SUNDRY NOTICES AND REPORTS ON WELLS
Do not use this form for proposals to drill or to re-enter an abandoned well. Use Form 3160-3 (APD) for such proposals.

5. Lease Serial No. **ROVD DEC13706**
NMNM 18325
6. If Indian, Allottee or Tribe Name **None**
7. If Unit or CA/Agreement, Name and/or No.
8. Well Name and No. **Many Canyon 29-04-26 #33**
9. API Well No. **30-039-29988**
10. Field and Pool, or Exploratory Area **Choza Mesa/Pictured Cliffs**
11. County or Parish, State **Rio Arriba, NM**

☒ Other Convert Vertical
well to Horizontal well

This well was originally permitted and approved as a vertical PC well. This new drilling plan addresses changing the un-drilled well to a horizontal PC well.

Job Number: 61xxx
 Company: Black Hills Gas Resources
 Lease/Well: Many Canyons 29-04-26 #33

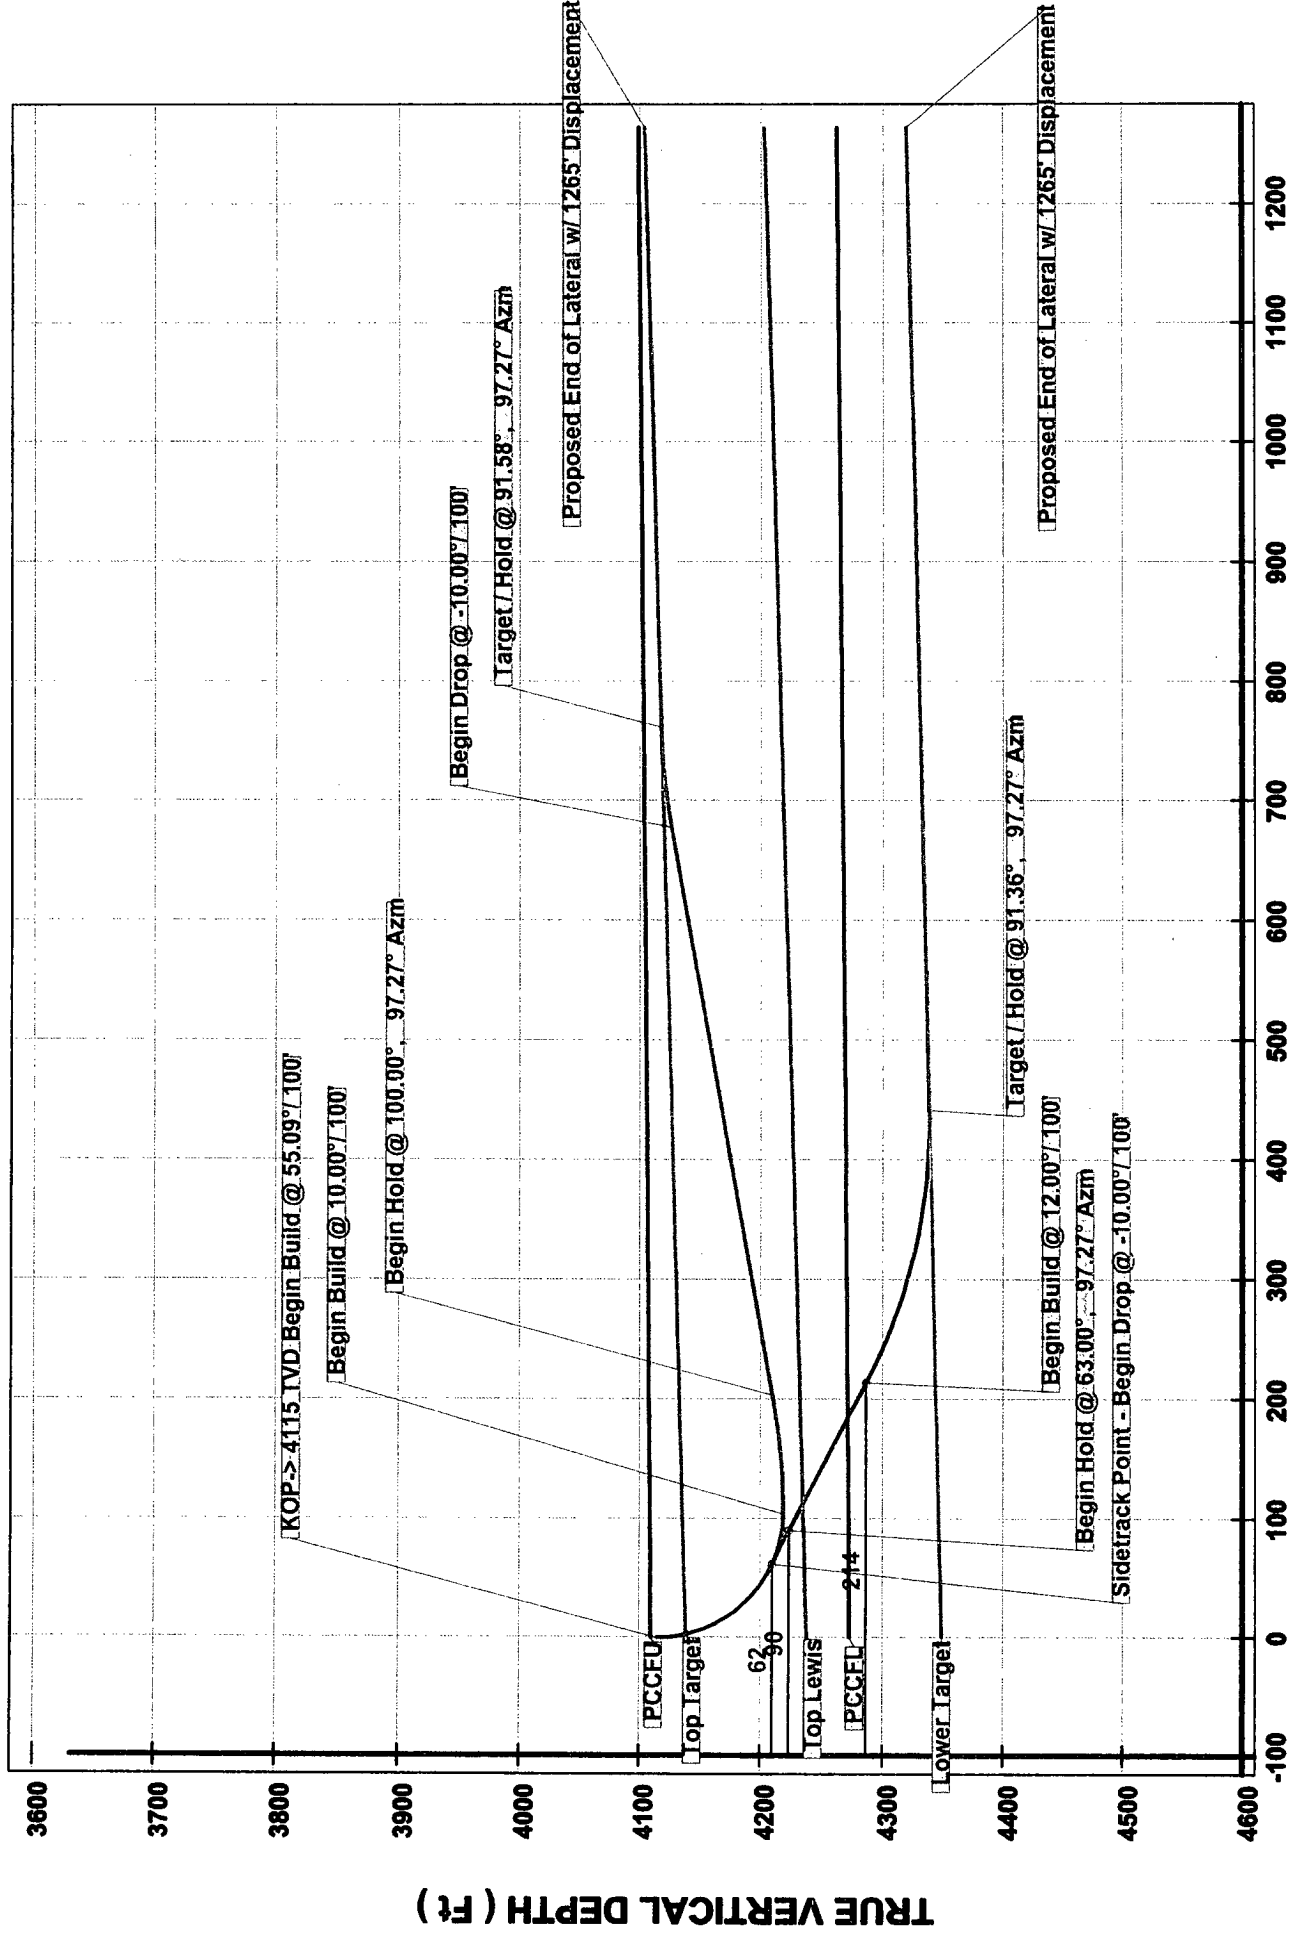
Geological data indicates that the PC formation is thick enough to support a dual PC lateral, therefore BHGR proposes to horizontally drill a dual lateral into the PC fomation. The laterals will have the same bottom hole location but will differ in elevation. One lateral will be drilled in the upper PCCFU (4139 bgs) and the second will be drilled in the lower PCCFL (4349 bgs).

Kick Off Point is estimated to be $\pm 4115'$ TVD
